# RESPONSE TO EDG COMMENTS

### SUMMARY OF BOARD GUIDANCE AT EDG

BOREN DESIGN REVIEW | 11.20.2018 | PAGE 40

## RESPONSE: TOWER DESIGN

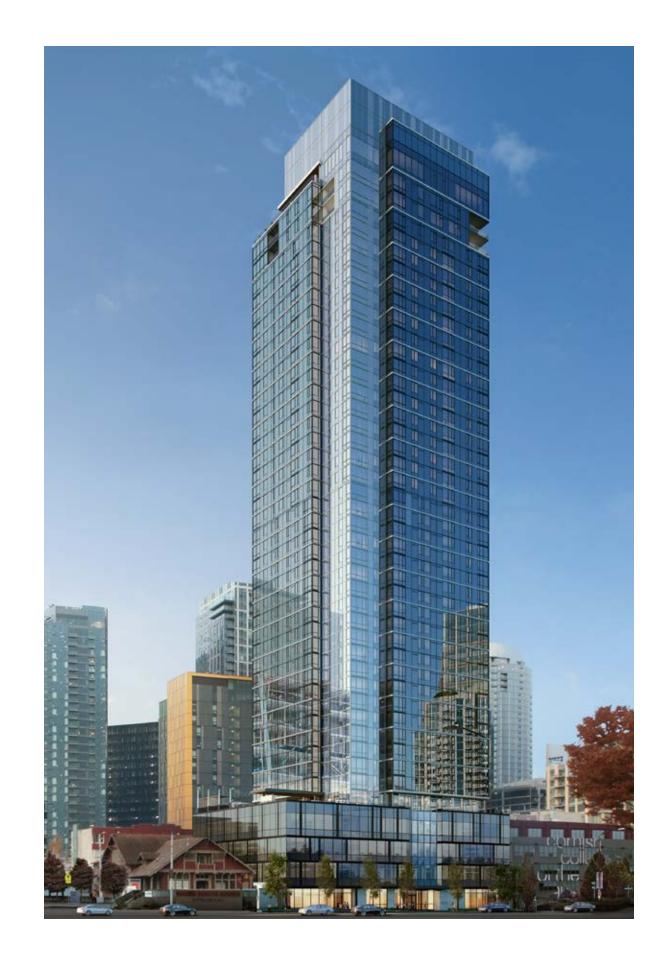
The Board was concerned that the staggered "vertical stripes" on the tower will date the design. The shifting of the facades to break up the tower volume is sufficient as a design move, and the vertical stripes are unnecessary.

Maintain the orthogonal shifts (massing) of the tower.

Per the boards guidance and concerns, we have removed the "vertical stripes" on the tower, retaining the same massing moves for the volume of the tower as at EDG. The **orthogonal shifts** in the tower are still **accentuated by two contrasting design languages**, the **central mass with a lighter**, **vertical expression**, and the outer elements are a deeper tone with stronger horizontals that create a rhythm up the tower.

### RESPONSE: TOWER DESIGN

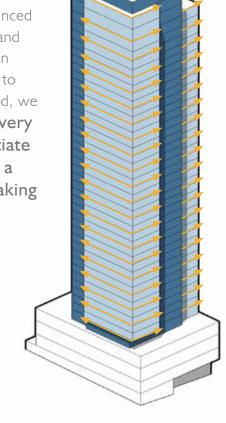
- Use the horizontal lines at the unit type shifts to break up the scale of the tower. (B4)
- The Board supported the change of scale at top of the tower and the consideration of the mechanical space design on the roof massing. (A2, B4)

The subtle horizontal lines at the unit stratifications were less legible when the vertical elements that announced their presence were removed, and some changes to the stratification levels left them un-proportional to what was shown at EDG. Instead, we used a horizontal pattern every other level to help differentiate the two masses and create a rhythm up the tower, breaking down the scale.

The rooftop screen was always envisioned as a graceful termination to the central mass and the sky. The design therefore evolved to more closely tie the two systems and languages together to create an element that will both feel unified and proportional but also enhance the skyline and create interest.

GASKET BETWEEN RAISBECK HALL AND CORNISH PERFORMING ARTS CENTER

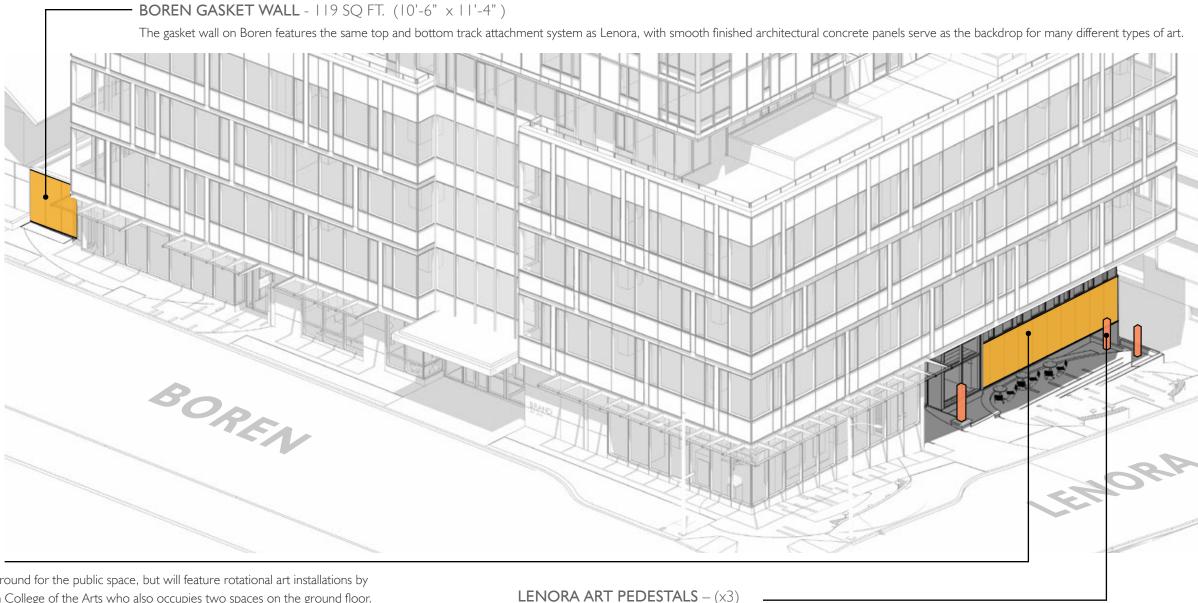
- The Board supported the setback from Raisbeck Hall. The gasket between the Landmark structure and the podium is an import feature. (BI, B3)
- 3.b. Provide uses on Boren Ave that will promote street activity. (CI, **C4**)

Between EDG and DRB, we studied the relationship between Raisbeck on our project and how the "gasket" could be a unifier between the two arts spaces that celebrates both uses. In collaboration with Cornish, we will develop another location for art along this wall, with a base of landscaping that continues the planting strategy in front of Raisbeck. In contrast to the highly transparent facades of the performance hall next door, this space will supplement both projects by creating a focal point at the center, and use smooth finish, architectural concrete similar to the Raisbeck podium to tie the two languages together.

**OFFICE AND GALLERY ENTRY OFF LENORA** – Artwork shown is for reference only.

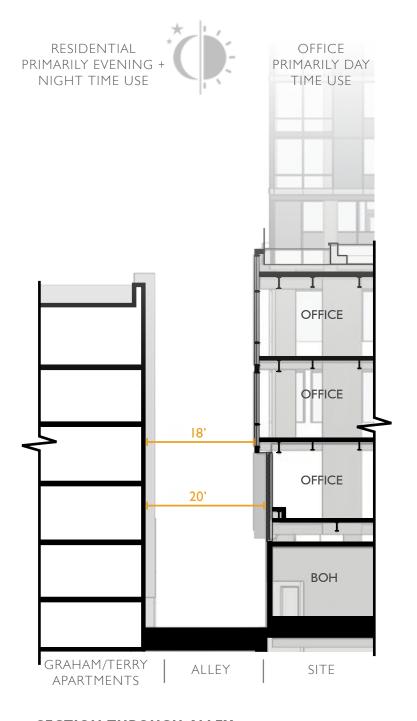
- 4.a. The Board supported the gallery at corner as it will improve connection to the neighborhood. (BI, CI)
- 4.b. Activate the blank façade on Lenora at the public amenity open space. (C1, C3, D1)
- 4.c. Provide a detailed study of the area at the entry to the gallery and office space in the podium and the public amenity open space along Lenora St. (CI, C3, C4, DI)
- 1.d. Show the relationship of the interior uses at the corner of Lenora St and the alley to the public amenity open space, at the sidewalk and the floor above. (CI, C3, C6, DI)

At EDG, the setback on Lenora was designed as a hill climb, integrating art, landscaping and stairs/benches to create a linear experience through the space. While that concept provided a benefit for the public, it did not address the boards concerns about activation and our own goals of creating a space for the neighborhood to interact.

The new design aims to be much more; not only does the art become a showcase in the space, but a stage-like plinth extends out creating platforms for impromptu performances, public gatherings and presentations. Benches wrap the entire space on both sides of the sidewalk, with larger landscaping beds softening the edges and housing platforms for the art installations. The feature office stair that was previously hidden frames the stair as a window of movement and transitioning between the art and office entry. Warm wood tones continue to wrap the soffit and wall framing the entire expression, and align in one unified expression that integrates lighting for the artwork.

#### **ROOFTOP COVERAGE**

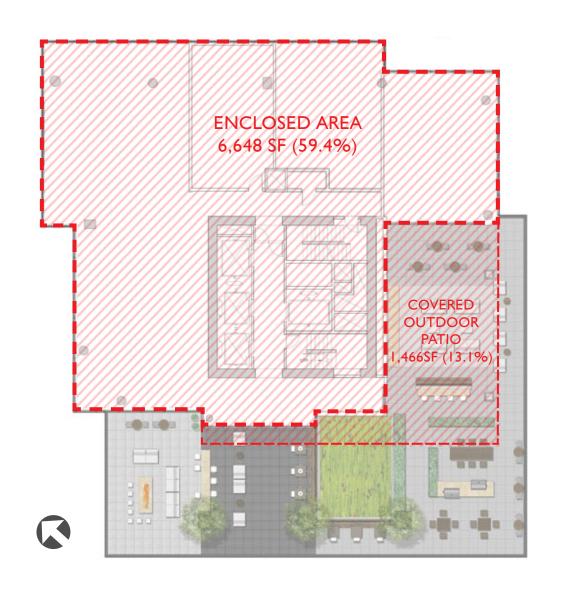
To provide residential amenity, mechanical spaces and screening, this departure proposes to increase the rooftop coverage from 55% to 72.4% (or only 59.4% when excluding the outdoor coverage area).

55% of the 11.199 SF roof area is 6,159 SF. The requested 8,114 SF is 72.4% of 11,199 sf, or a difference of 17.4% (1,955 sf). If you exclude the 1,466 sf covered outdoor area, then the coverage is 6,648 sf, or 59.4% coverage, a difference of 4.4% (489

Our preferred option allows the tower's three massing forms to terminate organically, each at different heights, allowing the residential floors, amenity level, and mechanical screen to blend together seamlessly rather then a harsh transition at the height limit.

#### UPPER LEVEL SETBACKS

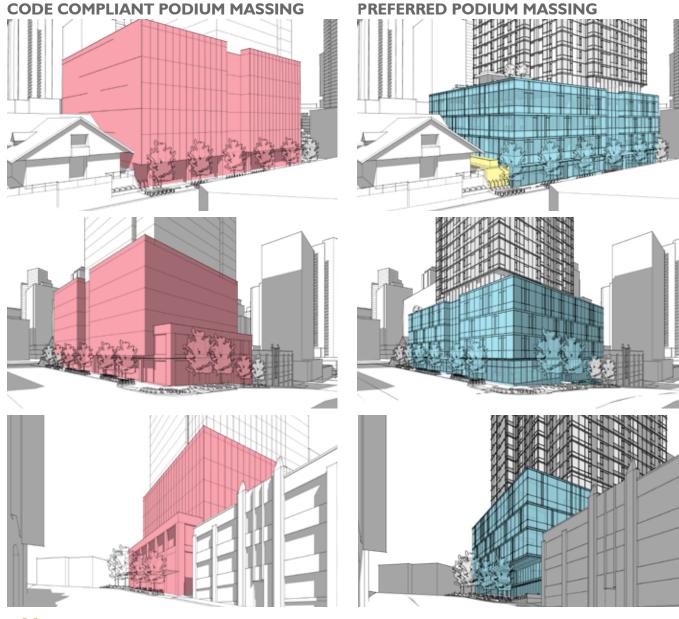
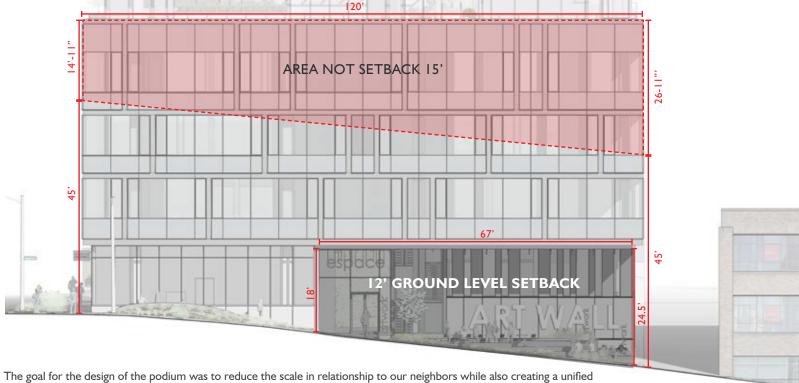
To provide light and air for Raisbeck hall, a landmark building, and a more unified podium design on a sloped site, this departure proposes to intrude into the 15' upper level setback between 14'-11 1/8" and 26' - 11" based on the slope of Lenora St.

26'-II" at NW corner and 14'-11 1/8" at NE corner as measured from L5 floor level to 45' datum.

The podium height as designed (59' - 47/8" as measured from average grade datum along Boren), is held down to be (26' - 7 1/8") less than the maximum height allowed by code (85'-0"). Sun and shade studies show no appreciable impact on sunlight on Lenora for the proposed podium height as compared to the code compliant option. As a tradeoff for the departure, the project proposes to provide an enhanced green street experience that promotes pedestrian interaction. The design sets back the LI facade 12'-0" from the property line. This additional area gained through the setback creates landscaped eddies of pedestrian activity, which would include seating and art installations. The towers massing also includes a three tiered facade along Lenora that cascades away from the 15' setback requirement. Finally, a voluntary 15' podium setback is proposed along the south property line adjacent to the existing Raisbeck Performance Hall, allowing more light to the north side of the existing landmark structure. The project does not gain developable area with the departure either. While the project gains 3,598 sf in area due to the setback departure, it voluntarily gives up 5,397 sf for the 15' setback along Raisbeck, 850 sf for the LI setback, and nearly 14,000 sf of unrealized development potential for not maximizing the podium height. Therefore the proposal takes a net loss of 16,649 sf of developable area in trade for the departure. Associated Guidelines:

#### **OVERHEAD WEATHER PROTECTION – DEPTH**

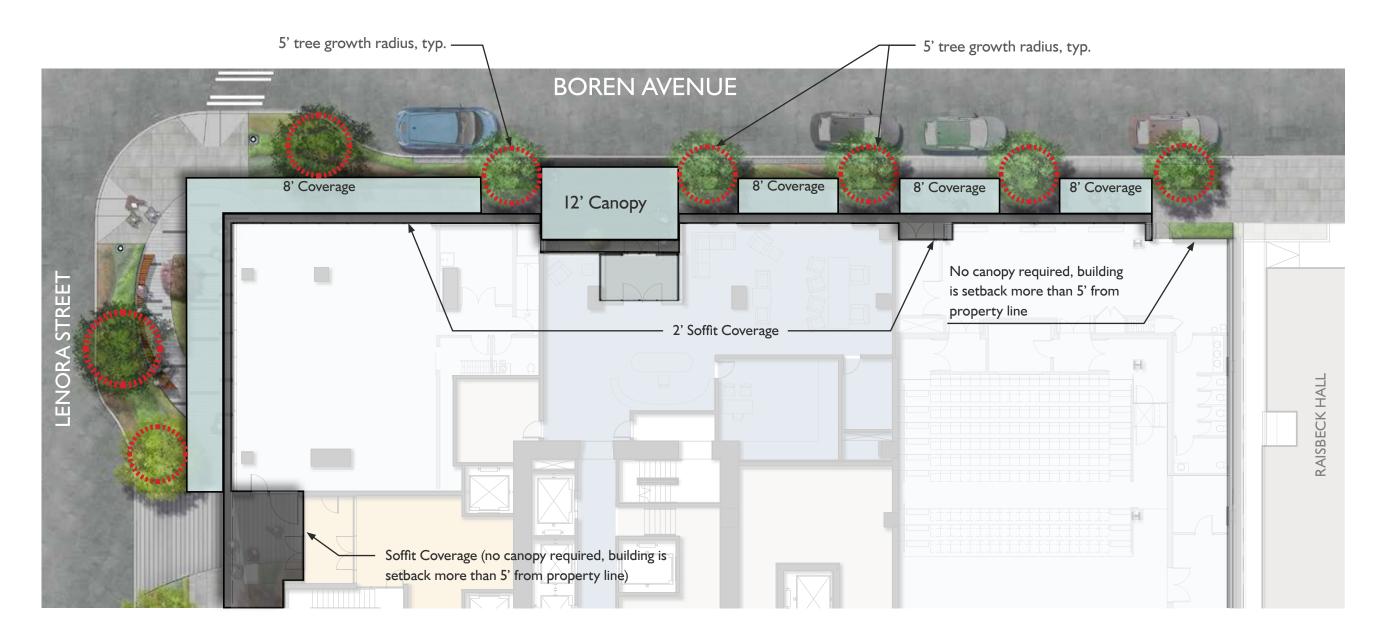
To accommodate street trees, this departure proposes to reduce overhead weather protection canopy depth from 8' to 2' in certain locations (protection provided by building soffit).

Proposed overhead protection is 8' deep from exterior face of building, where canopies are present, and 2'-0" canopies conflict with trees.

The zoning code requirement for 8' deep overhead protection conflicts with Seattle standards for tree planting in a 12' sidewalk. SDOT requires tree trunks to be 3.5' from curb. In this condition, the centerline of the tree trunk would be 6" from the edge of a compliant canopy which would not allow the tree to fully develop. SDOT from exterior face of building face where requires 5' radius from tree trunk to provide enough room for trees to grow and remain healthy. This benefits the public by providing shade to the pedestrian realm, and adding to the long term urban forest.

#### **ALTERNATE CANOPY DESIGN**

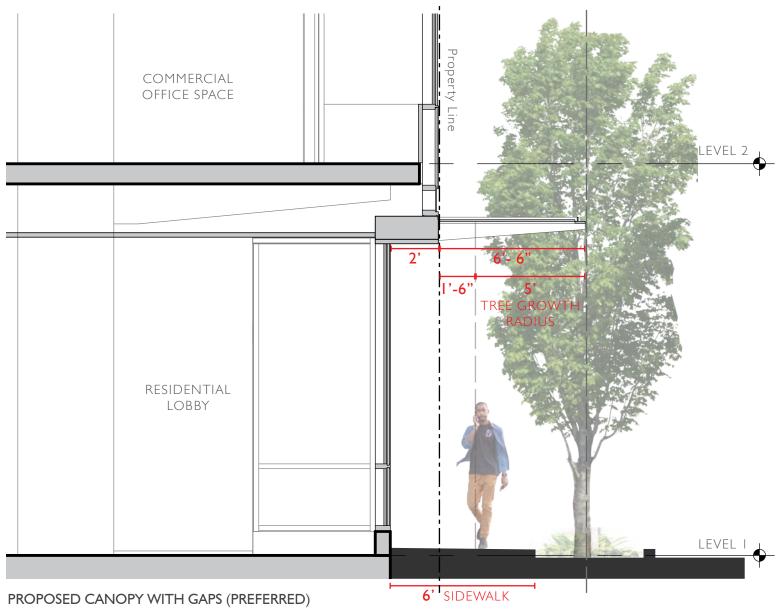
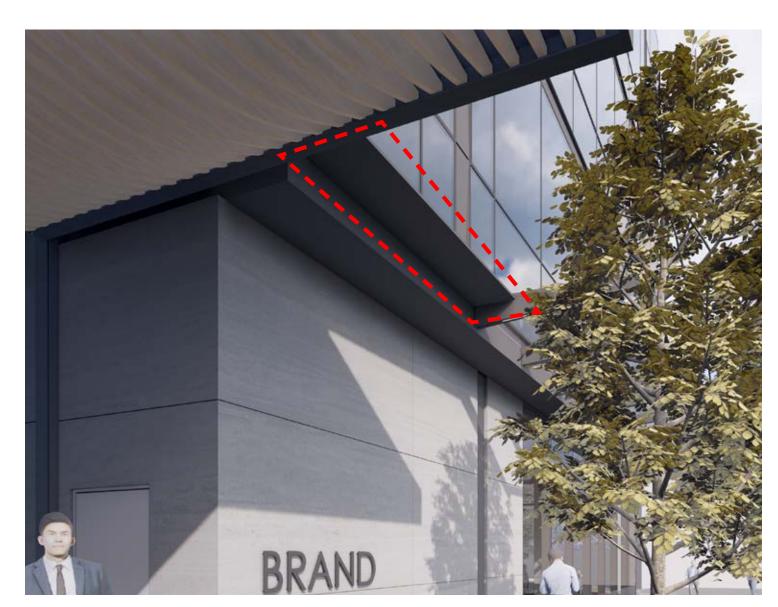
At EDG the board asked the design team to explore a canopy option where the 1'-6" gap between the 5' tree growth radius, and the 2' soffit, is covered with a small canopy.

In developing this study we discovered the application of a short canopy between tree spans creates a drip line in the center of the walking path. See detail below. Additionally the full depth canopy design does not lend itself to a 1'-6" depth dimension. Our design solution to fill the canopy gap at the trees along Boren with a horizontal plate detail (matching the soffit color) and allow the soffits to create 2'-0" of weather protection, creating a 3'-6" covered area against the building. Both from a design standpoint, and practicality of drip line location, our preferred solution is to break the canopies at the tree locations with a 10' gap and not try to introduce the additional plate, leaving a clean modern aesthetic and complementary connection of the ground level to the podium.

Due to the setback of the building at grade, there will still be weather protection provided by the 2' soffits above.

#### **OVERHEAD WEATHER PROTECTION - HEIGHT**

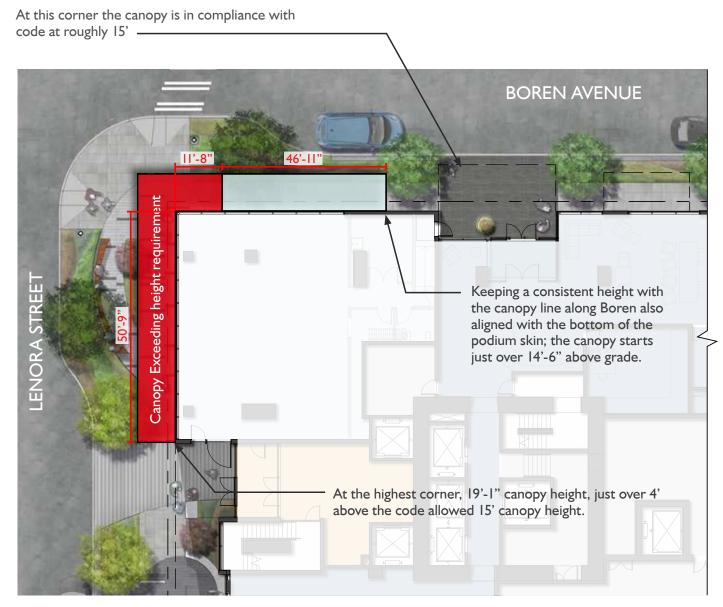
To provide a uniform canopy design on a sloping site, this departure proposes exceeding the 15' height up to 19' - 1 1/4" as the site slopes along Lenora.

Up to 4'-1 I/4" of additional canopy height above the sidewalk.

In order to maintain a single canopy height for the arts facility space at the corner along a sloped site, we need to exceed the maximum canopy height along Lenora. This will allow the arts facility space to maximize unobstructed display space visible from the street, and create a more uniform space inside and out for art display and viewing.
